Rezoning Transportation Analysis

Petition Number: 2021-163

General Location Identifier: 08002304

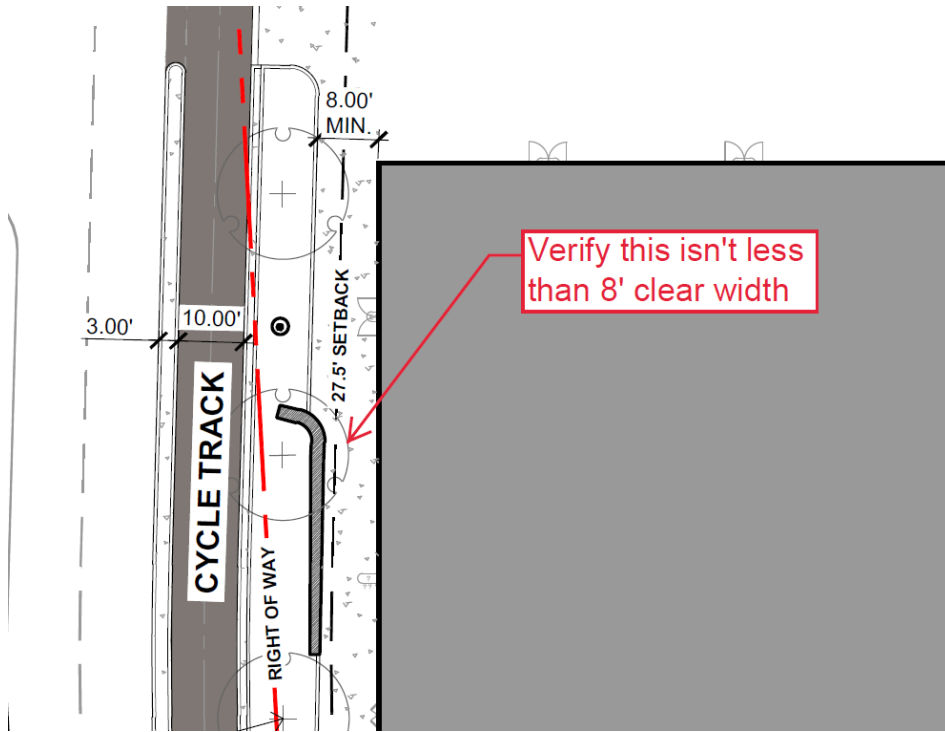
4. **6th Street Cross-Section:**
 - ~~a. **New Cross-Section:** Include a second cross-section that shows a consistent 10' cycle track width and 11' travel lanes.~~
 - ~~b. **Right of Way:** Show right of way line on cross-section and ensure building face is outside of right of way.~~
 - ~~c. **Pedestrian Pathway:** Update site plan and conditional notes to show minimum 12-foot sidewalk width. **Updated per Site Plan Dated 09-13-2021: 8-foot minimum sidewalk consistent with all other streetscape improvements in area. Verify that 8-foot sidewalk is achieved as it appears to be less than that in an area below the dimension on the site plan:**~~

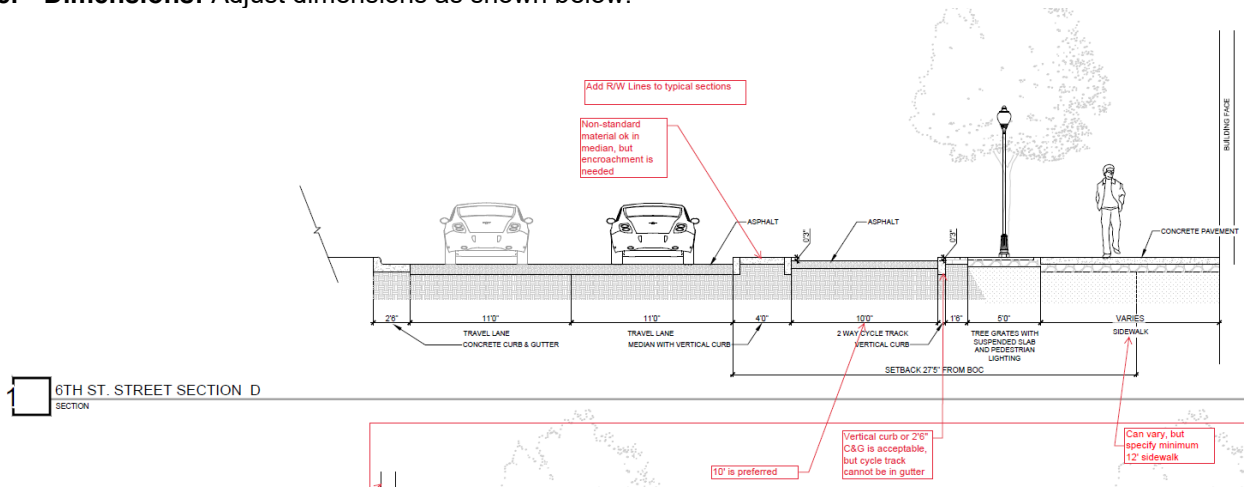
d. **Cycle Track:** Update site plan and conditional notes to show the correct and varied dimensions, as shown below. Add a conditional note that vertical curb and curb and gutter are both acceptable adjacent to the cycle track, but the gutter width cannot be used to account for the 10' cycle track width. Add a conditional note that nonstandard material is allowed in median between cycle track and vehicle travel lanes, but an encroachment permit will be required. Additionally, provide a conditional note that specifies the commitment of constructing the cycle track on 6th Street.

5. 7th Street Cross-Section:

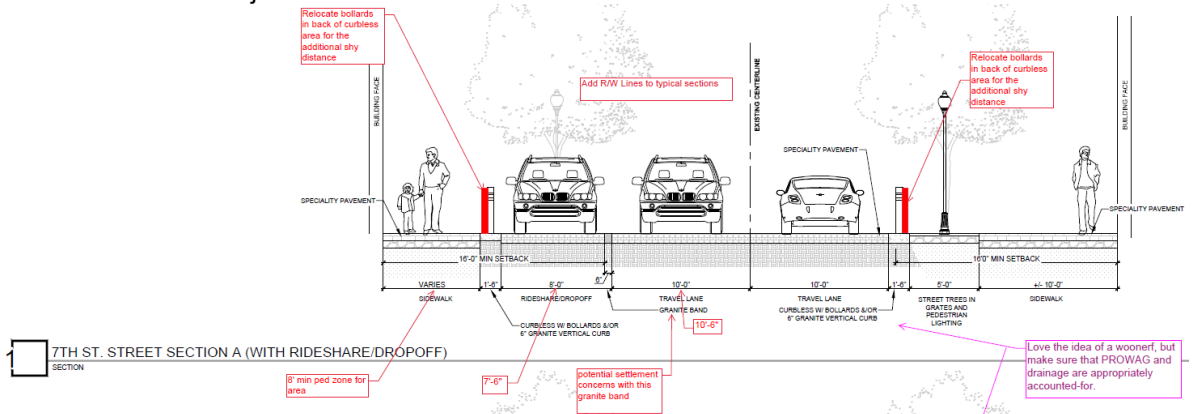
e. **Dimensions:** Adjust dimensions as shown below:
